ADDENDUM NUMBER 03

DATE: January 31, 2024

PROJECT: Cass District Library Edwardsburg, MI

PROJECT NUMBER: 22-1836

1 REFLECTED CEILING PLAN - FIRST FLOOR
A2.1 1/8" = 1'-0"

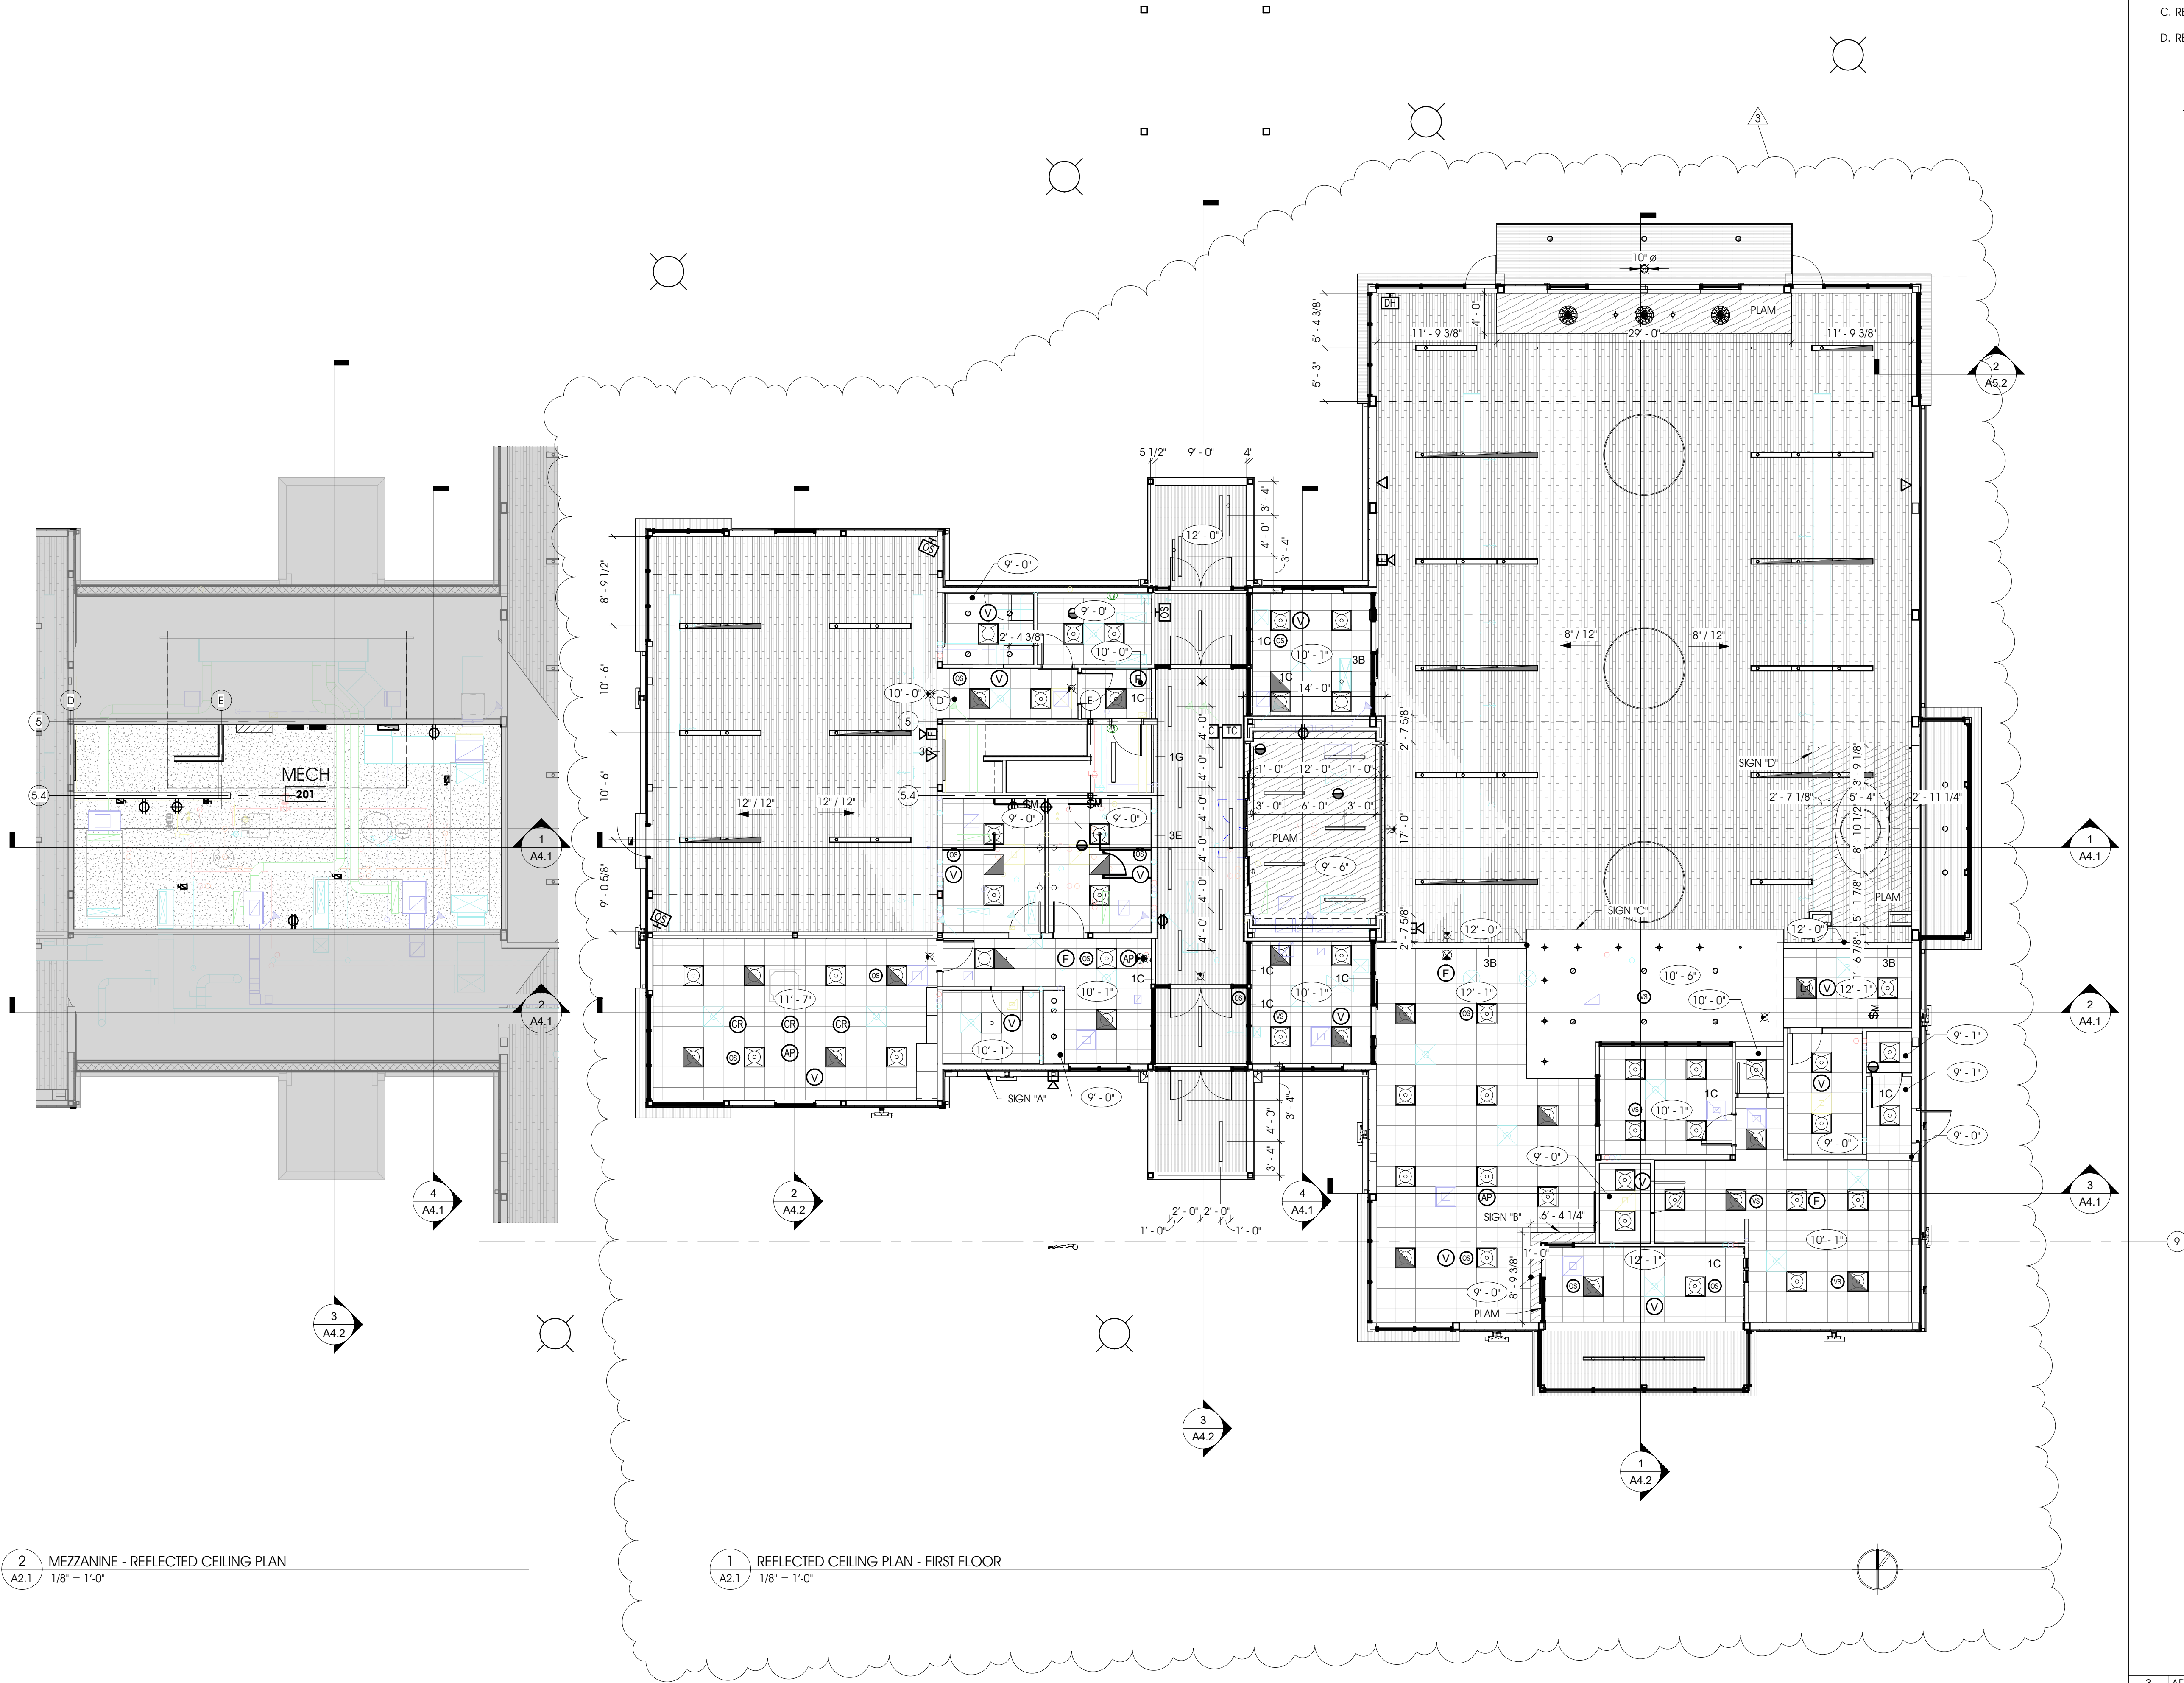
12. **REVISE** Dimensions and ceiling finish materials for clarity.

62. How do we know the extent of the PLAM-2 wall panels noted in the finish plan on A8.1 when the areas aren't shown in elevations? For instance, the finish plan shows PLAM-2 at the fireplace, but it is not noted in the fireplace details on A6.4. The finish plan also shows PLAM-2 all around the library shelf room, but the enlarged floor plan on A6.0 doesn't show it at all.

- a. Please see revised sheet A2.1 FIRST FLOOR REFLECTED CEILING PLAN for details.
63. Opening 109-B has missing hardware set?
- a. Please refer to section 087100-31 – DOOR HARDWARE, for door 109B with revised hardware set #14.
